**Historic Preservation Review City Hall - 1711 Miner Street,  
Idaho Springs, CO 80452 Agenda**

# IDAHO SPRINGS HPRC STAFF REPORT

## **Certificate of Appropriateness (COA) COA26-001 – Entry Ramp at 1921 Virginia Street**

## **Certificate of Appropriateness (COA) COA26-002 – Entry Door, Window Replacement, and Mechanical Equipment at 1743 Miner Street**

Zion Church Entrance  
Site Plan

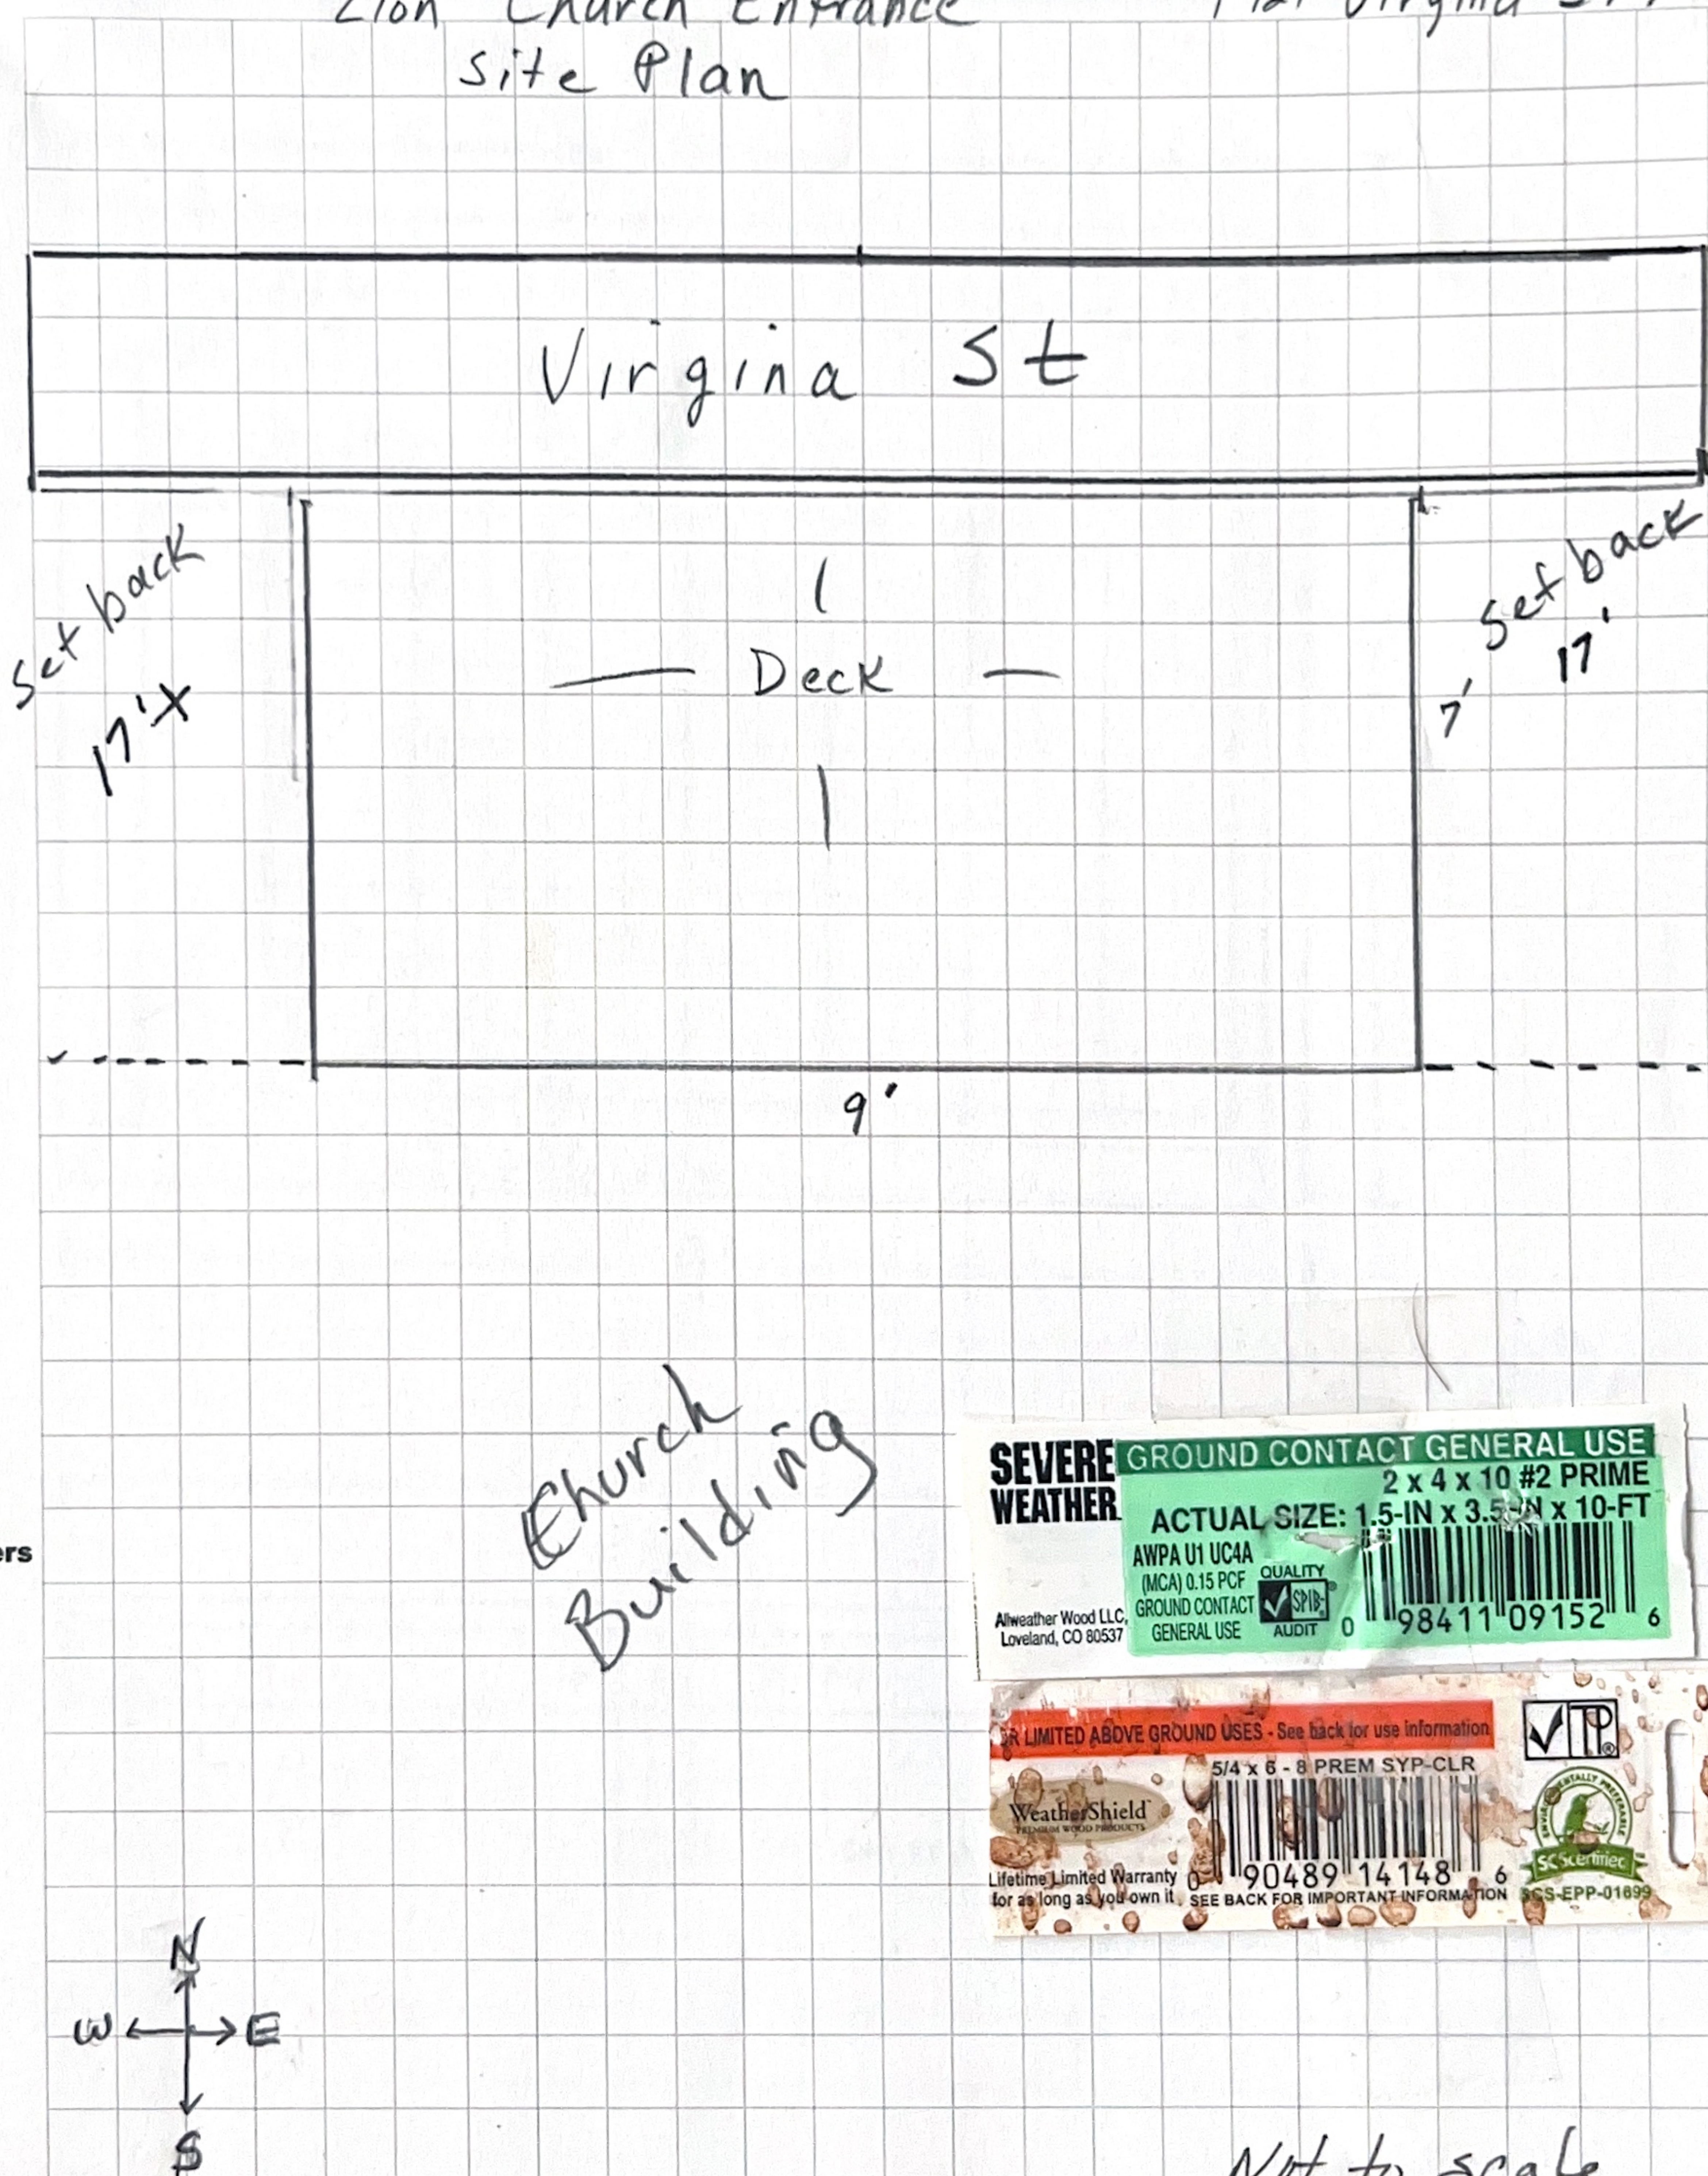
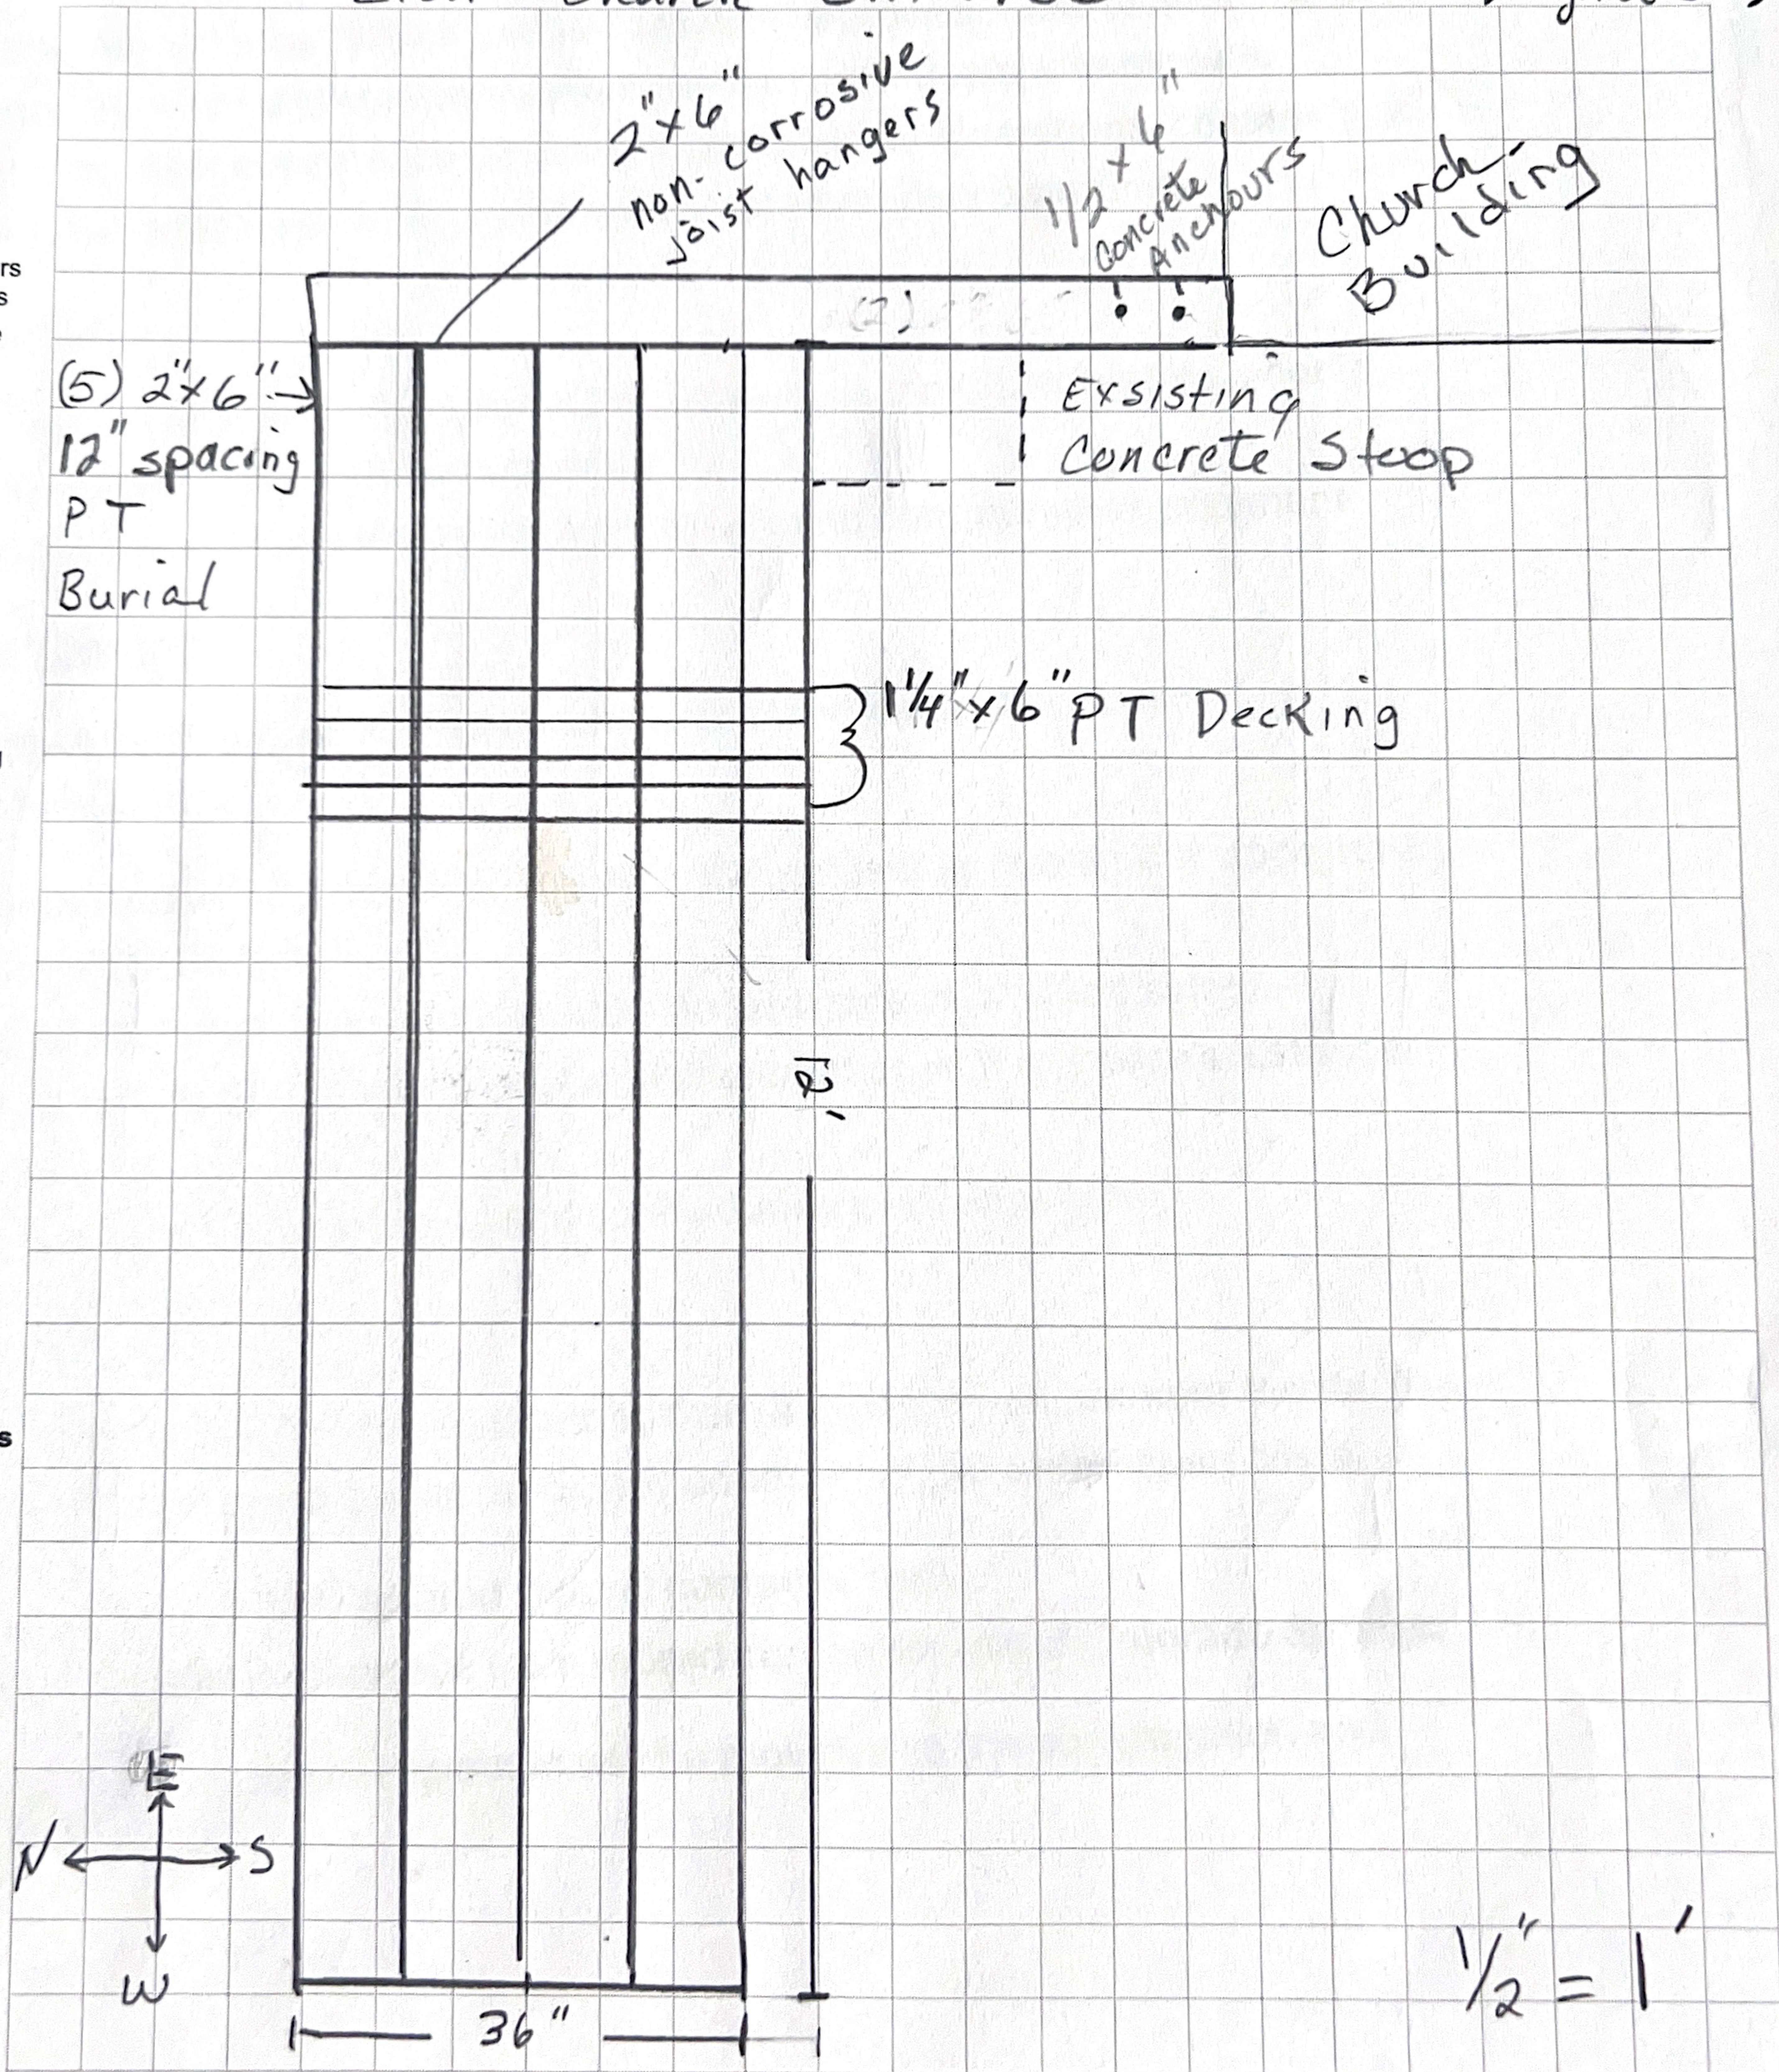
Staff believe that the existing concrete staircase to enter the building and the proposed wooden ramp encroach on city Right-of-Way (ROW). The existing stairs have been in place for decades but this new ramp improvement needs a license agreement to remain in place on the city's ROW. If HPRC determines that this project can be approved, staff recommend that it be approved with a condition that a license agreement be required to allow the ramp in the city's ROW. If a license agreement cannot be secured, the HPRC approved would be invalidated and the ramp would need to be removed.

Staff do not believe that the proposed work will adversely materially affect the structure's historic quality. The proposed wooden ramp is "permanent" in that it is affixed to the ground and to the exterior of the church, but it is a minor addition to the building, rather than a change to the building itself. If the ramp were to be removed in the future, it would have no lasting, permanent impact on the historic structure.

Additionally, the ramp is unlikely to obscure the historic features of the existing structure. The historic integrity of the building will be maintained.

The proposed work is unlikely to have an adverse material effect on the historic atmosphere of the Historic District. The ramp is wooden and features a simple design that does not detract from the property's historic character:

The ramp could benefit from painting to match the current color scheme and protect the wood. Staff would recommend that the ramp be painted to match, though the *Design Guidelines* do not require paint. Nevertheless, the ramp currently seems to stand out because it is not painted and painting it white to match the main building color may help improve its aesthetic appeal.

Applicant shall execute a license agreement with terms acceptable to the City for that portion of the improvement located within the City's right-of-way and the City may decline to execute same in its sole discretion and be under no obligation to enter into same. In the event applicant and City do not enter into said license agreement, applicant shall submit a revised application for HPRC consideration depicting a different design which removes the improvement from the City's right-of-way.

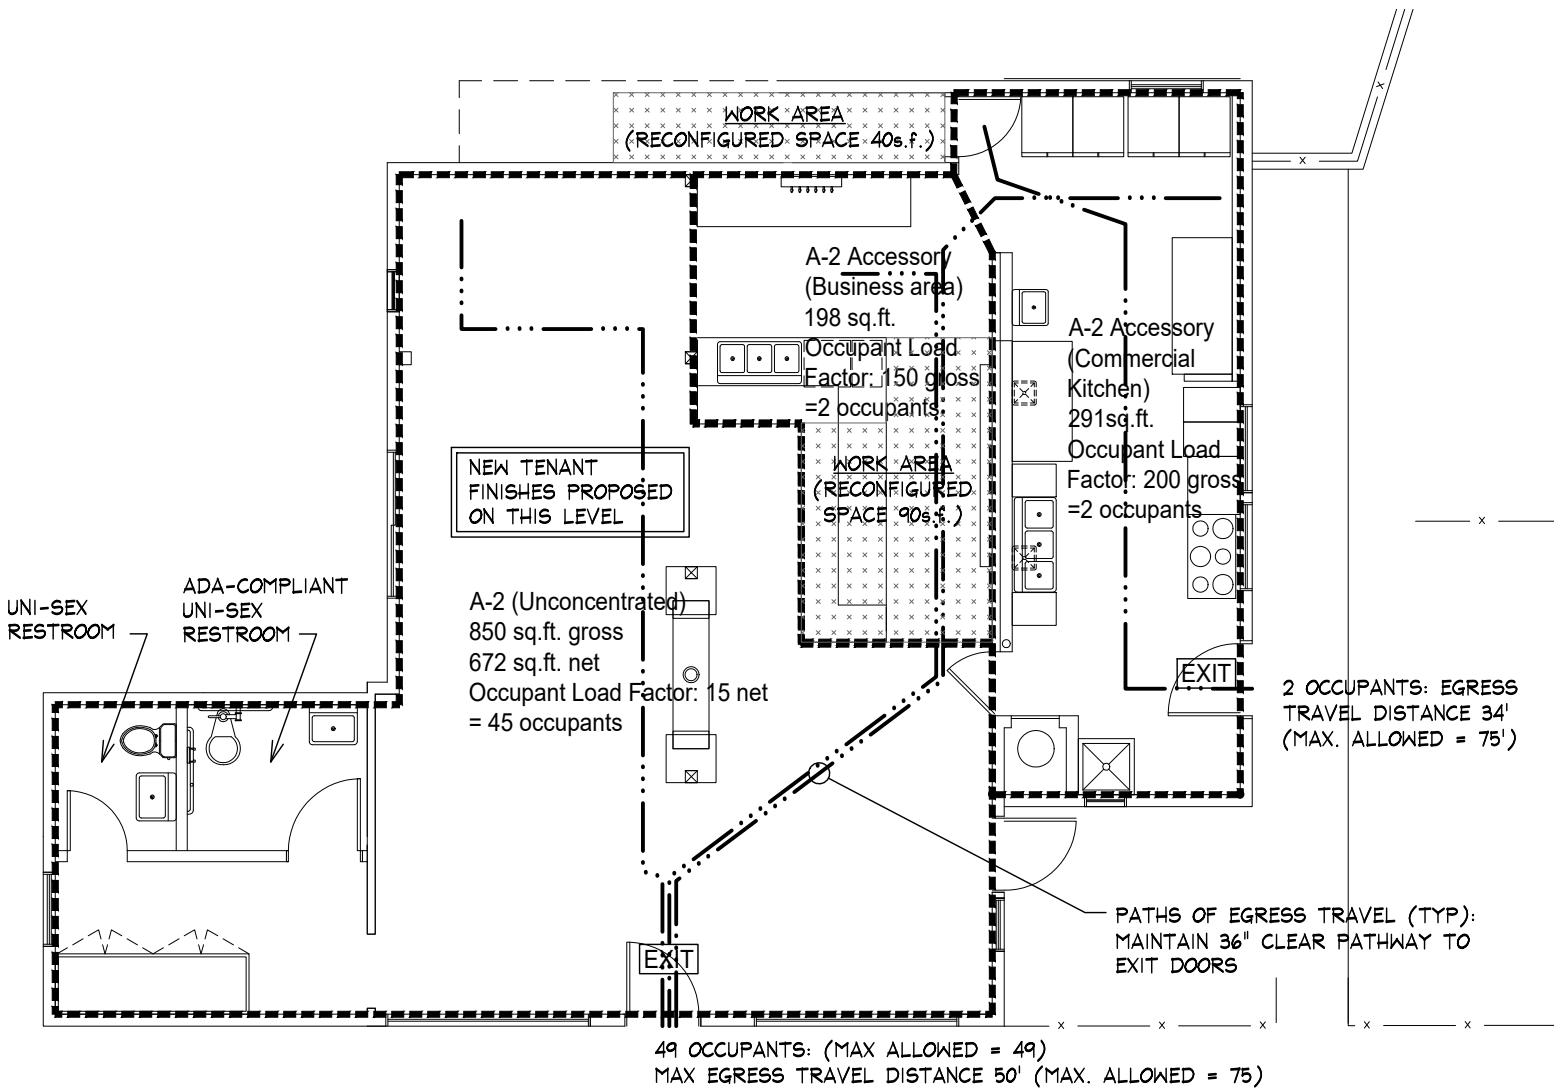
The mechanical equipment is necessary to construct a kitchen on the building. Historically, mechanical equipment has been found on the building's roof, as seen in this 1992 photo:
